PRODUCT BULLETIN #486

#14 TORFLEX® AXLE MOUNTING DESIGN CHANGE

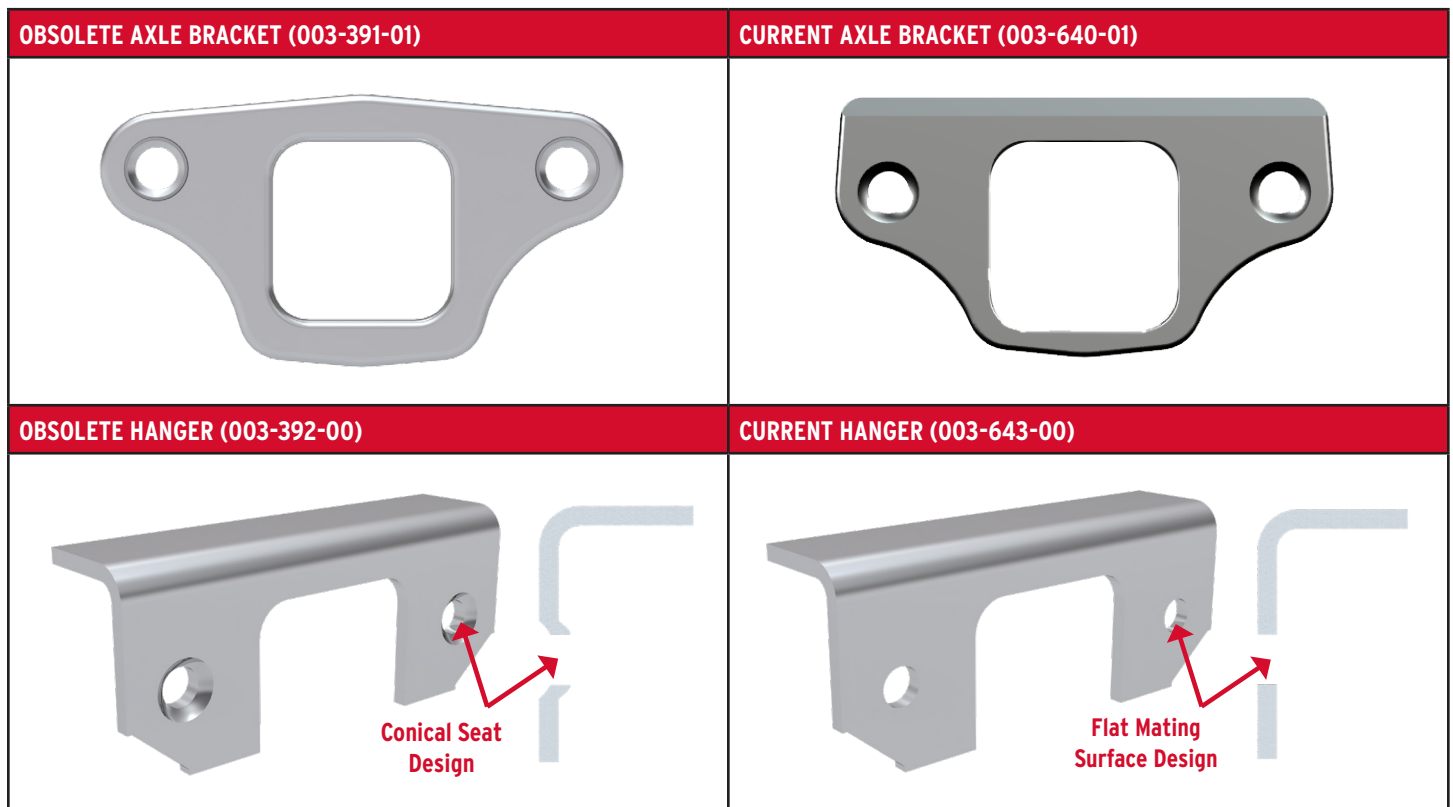
Dexter modified axle brackets and hangers for 12,000 lbs. capacity #14 Torflex axles in production in April 2018. This modification created a flush mating surface between the axle mounting and frame bracket, replacing the conical seat fastener attachment.

- If replacing an axle built prior to May 2018 which included obsolete axle bracket (003-391-01), it is okay to replace with an axle manufactured after April 2018 that utilizes the current axle bracket (003-640-01). The obsoleted hanger (003-392-00) can accommodate axles built after April 2018 with the current axle bracket (003-640-01).
- If replacing an axle built after April 2018 which includes current hanger design (003-643-00) it must be replaced with an axle also built after April 2018 which utilizes the current axle bracket (003-640-01). **It is critical to not use an axle built prior to May 2018 which included obsolete axle bracket (003-391-01) and the current hanger design (003-643-00).**
